## PIC18C658/858 Rev. B2 Silicon/Data Sheet Errata

The PIC18C658/858 parts you have received conform functionally to the Device Data Sheet (DS30475A), except for the anomalies described below.

**FIGURE 1: PIC18CXX8 VOLTAGE-FREQUENCY GRAPH (INDUSTRIAL, EXTENDED)**

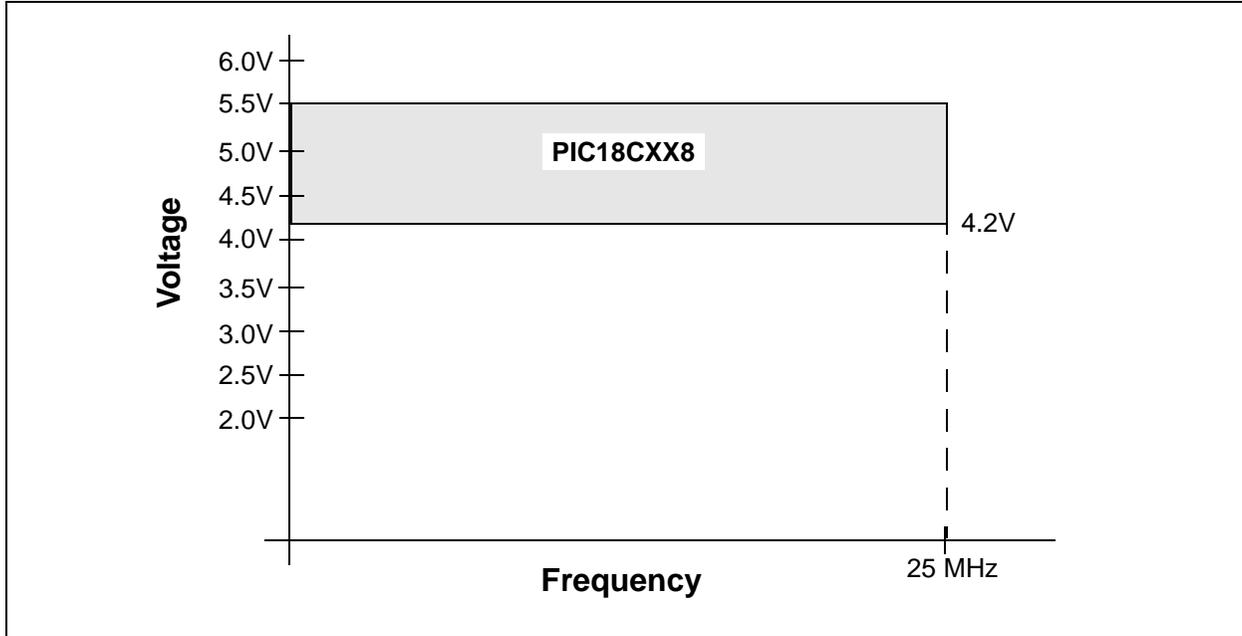
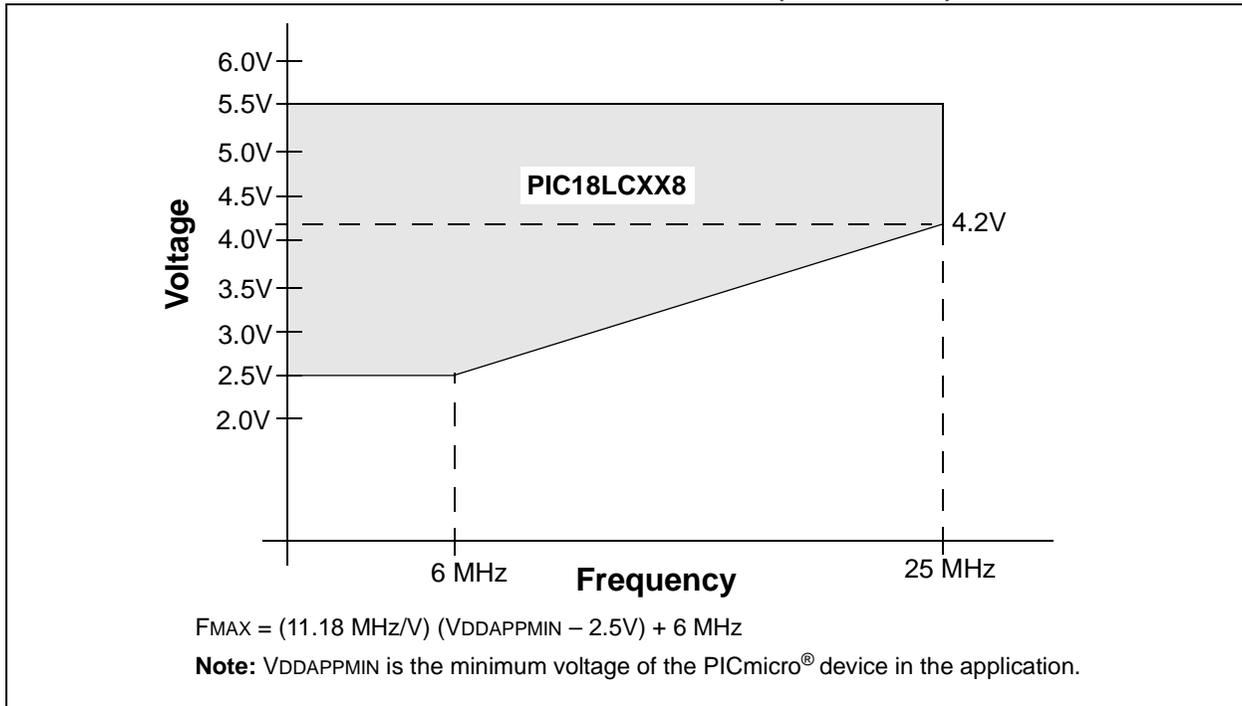
The device may not operate properly at frequencies exceeding 25 MHz. The graphs in Figures 1 and 2 (page 4) show the expected voltage vs. frequency operating range for standard voltage range and extended voltage range devices, respectively.

None. This issue is expected to be resolved in a future silicon revision. Please contact a Microchip sales office for additional information on availability.

### FIGURE 1: INTERRUPT LOGIC (EXCERPT)

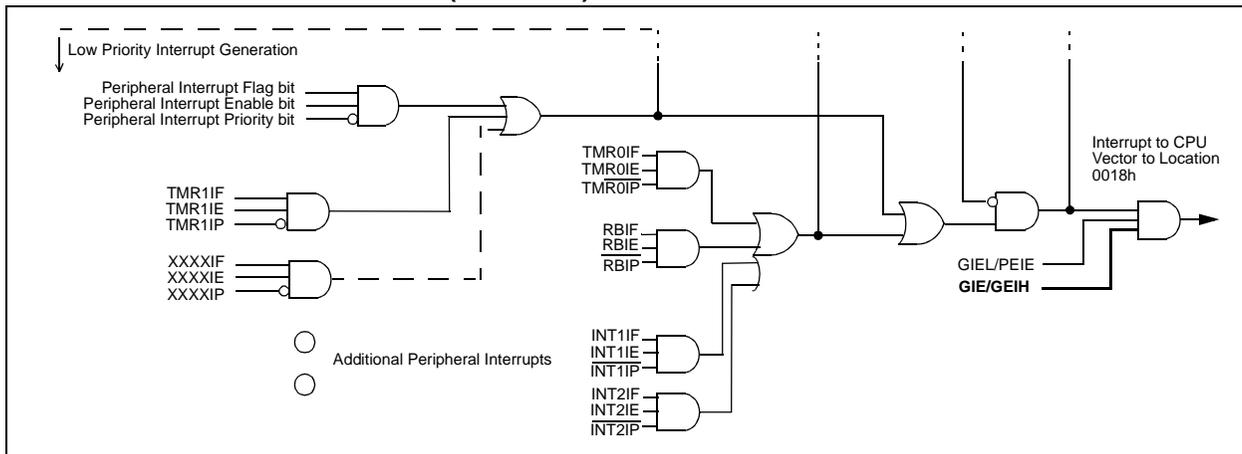
Also, the interrupt logic funnel shown in Figure 7-1 of the Device Data Sheet is amended with the addition of a GIE/GIEH control line, as shown in Figure 1 (new material in **bold line**).
